STATE OF MAINE  
DEPARTMENT OF TRANSPORTATION  
16 STATE HOUSE STATION  
AUGUSTA, MAINE 04333-0016

November 25, 2024

Subject: Highway Reconstruction, Bridge  
Rehabilitation & Lighting Replacement  
State WIN: 012800.30, 022258.00 &  
024363.00

Location: **South Portland**  
**Amendment No. 3**

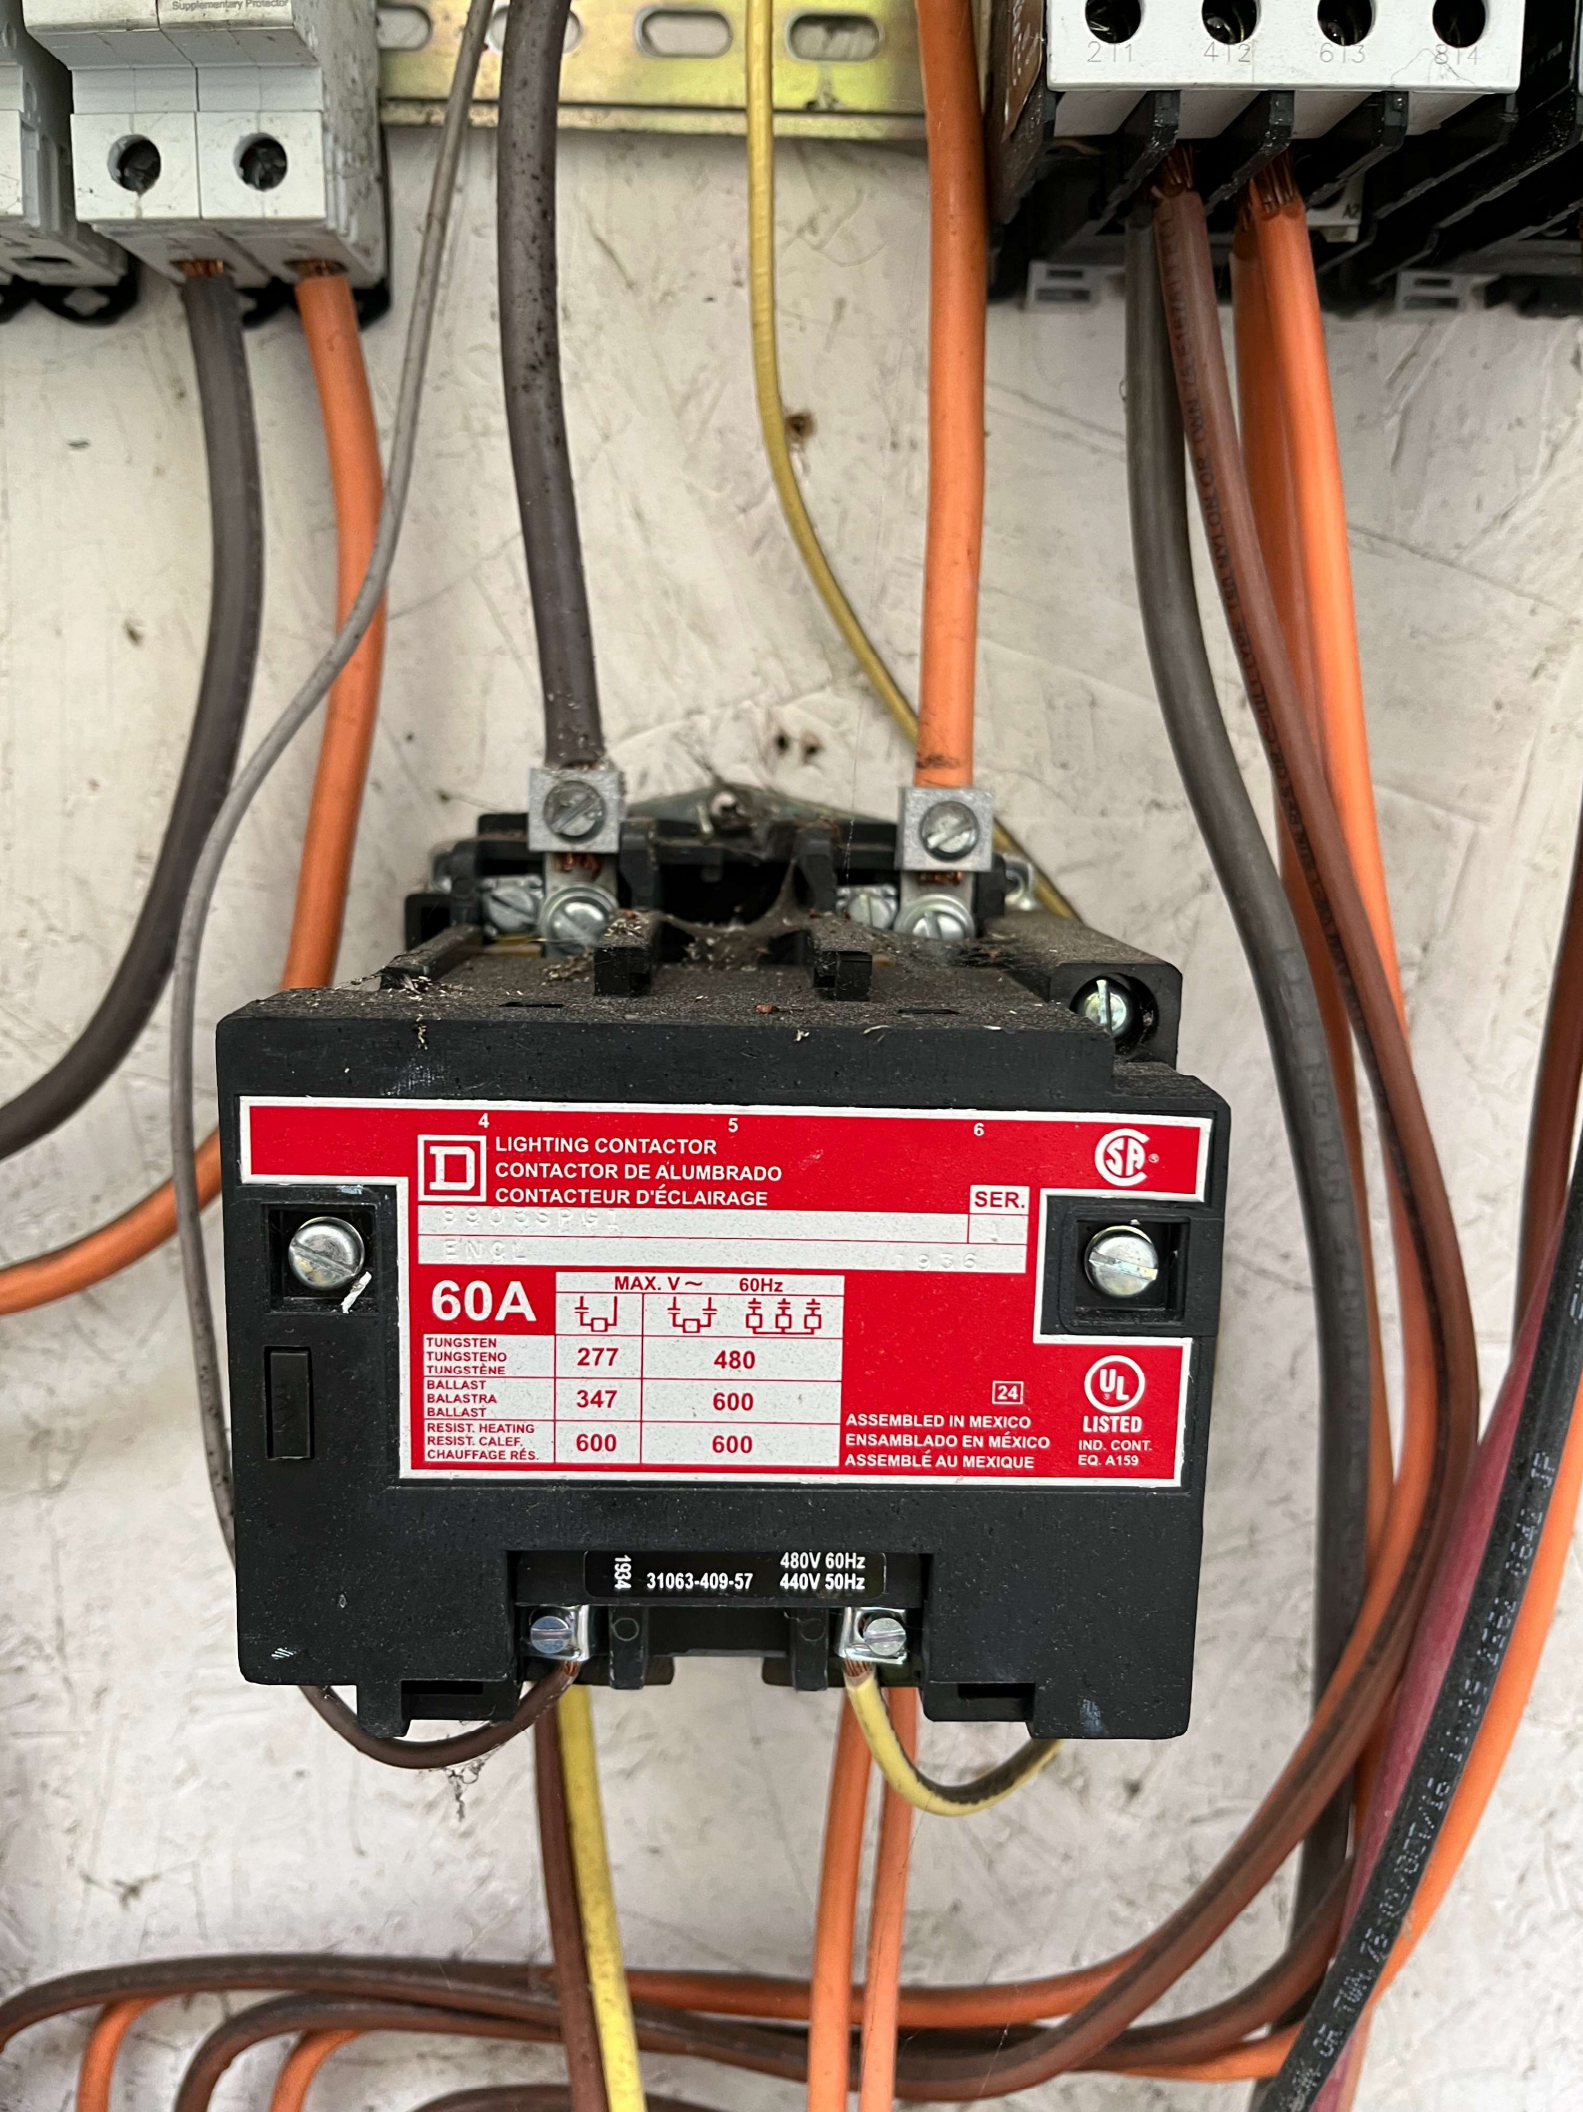
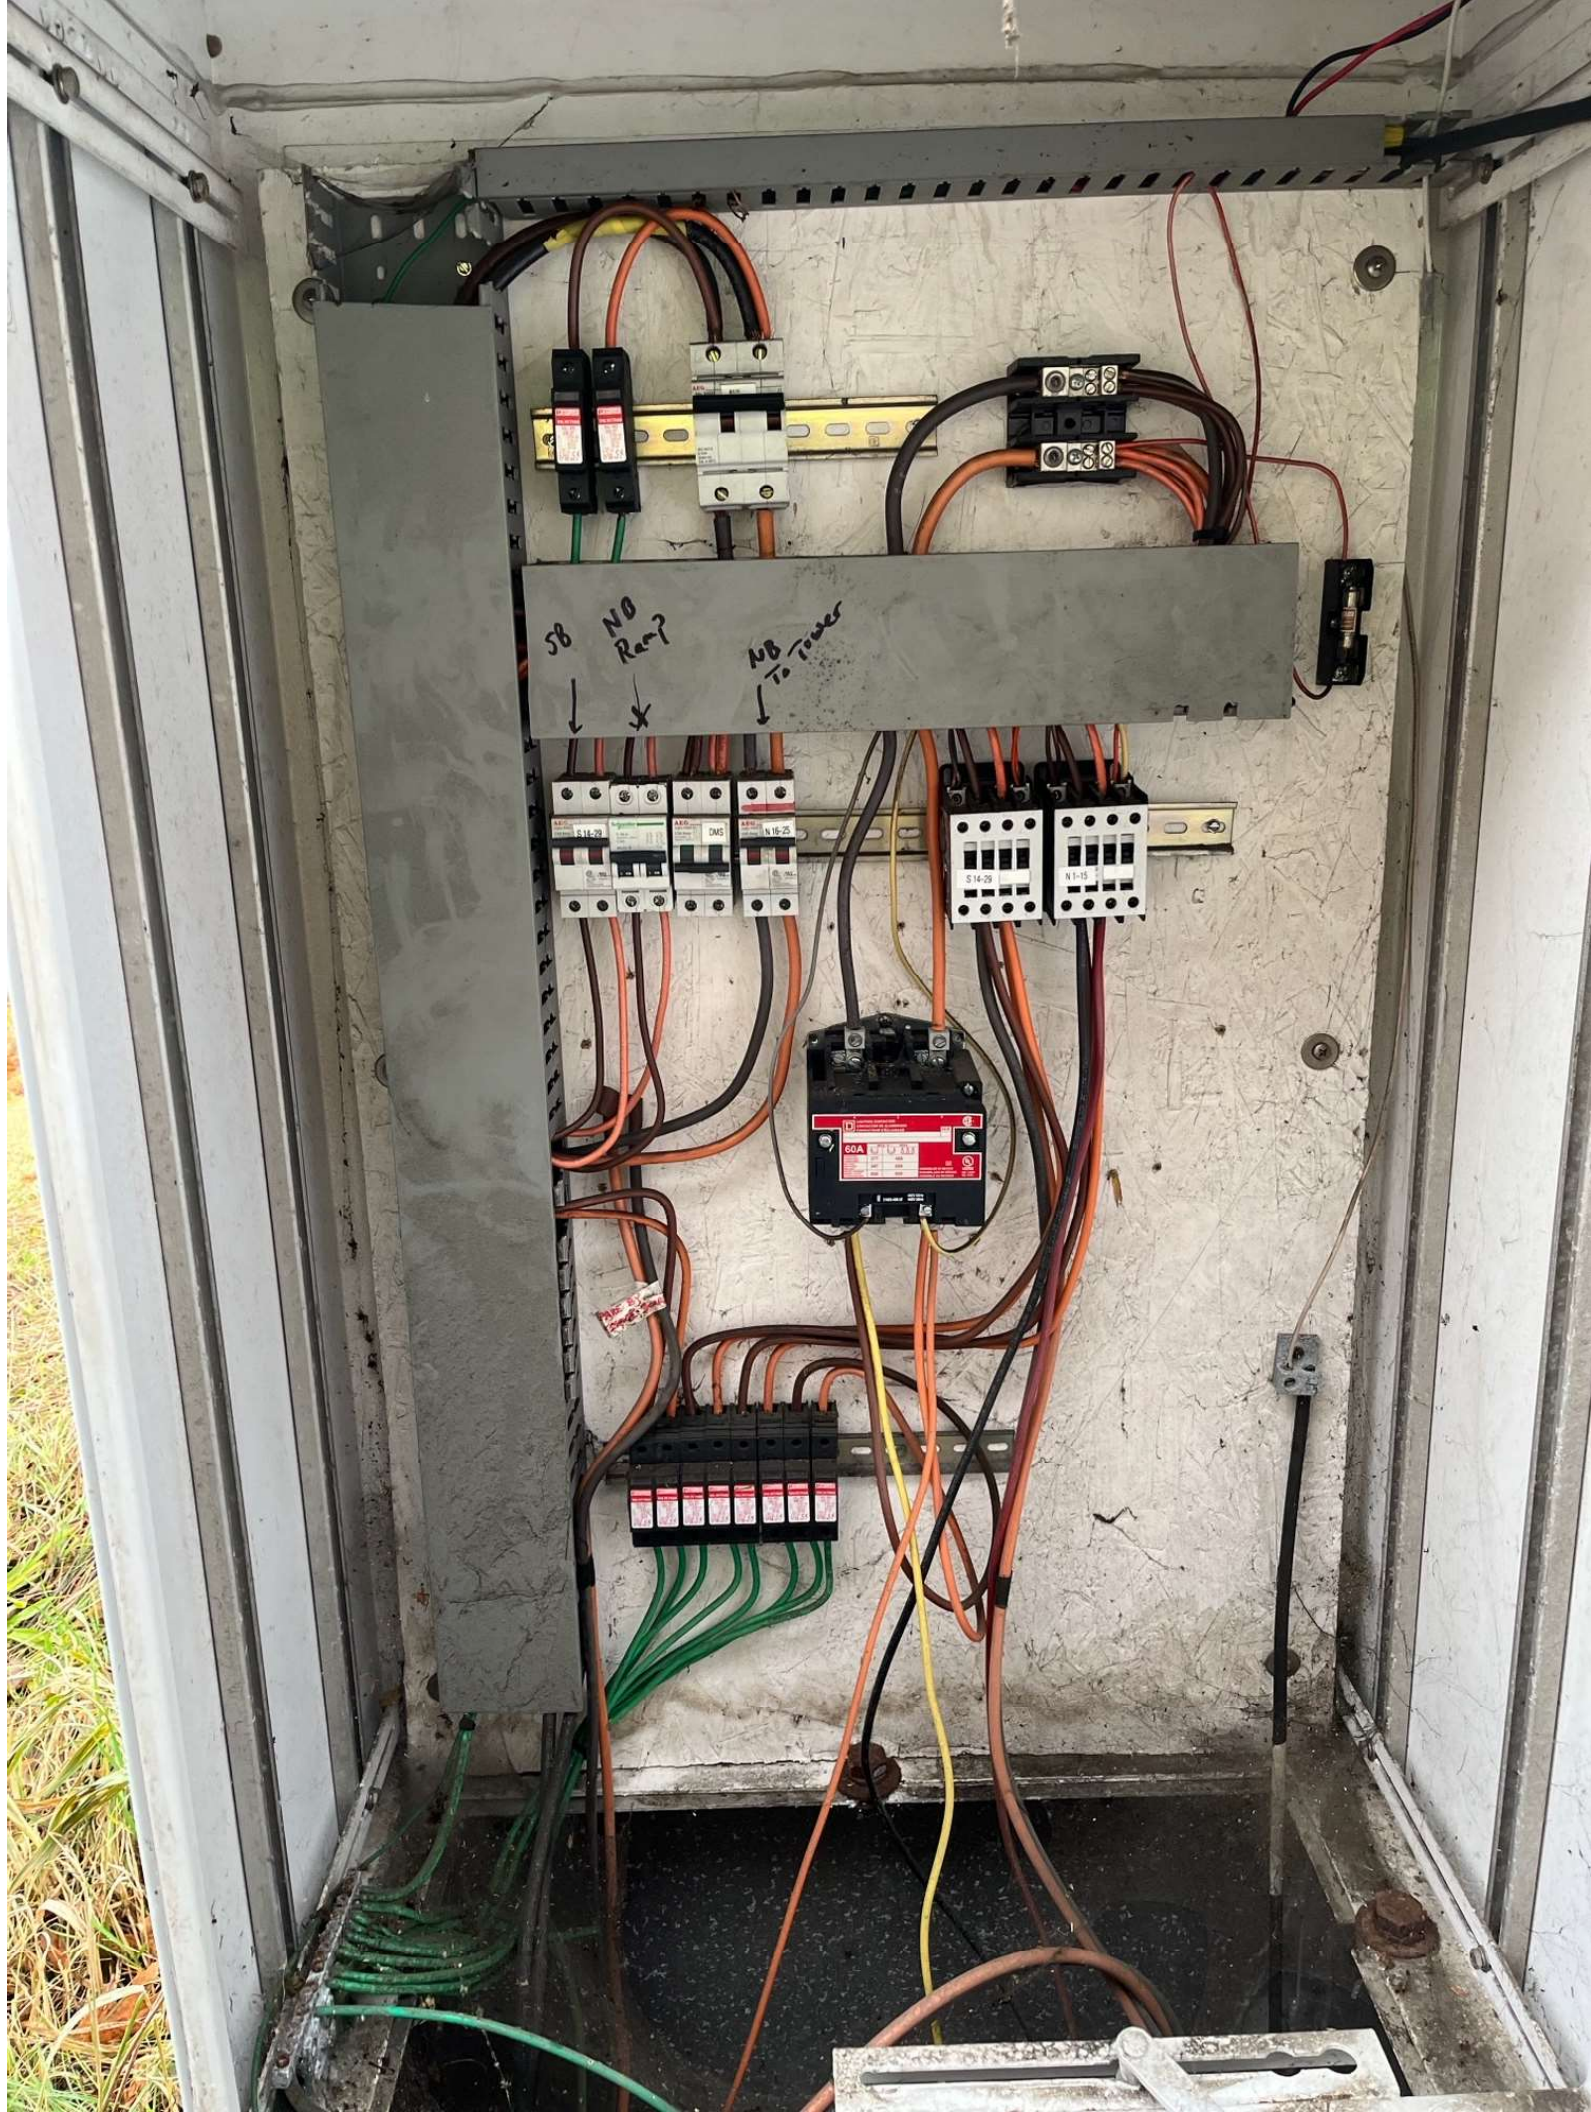
**Question:** Please provide additional details on the existing circuit breakers in the existing lighting cabinet that are to be replaced (i.e. number of breakers, voltage & amperage). We do not have any way of knowing how many circuits will remain in this cabinet.

**Response:** Pictures of the existing circuit breakers in the existing lighting cabinet are attached to this amendment
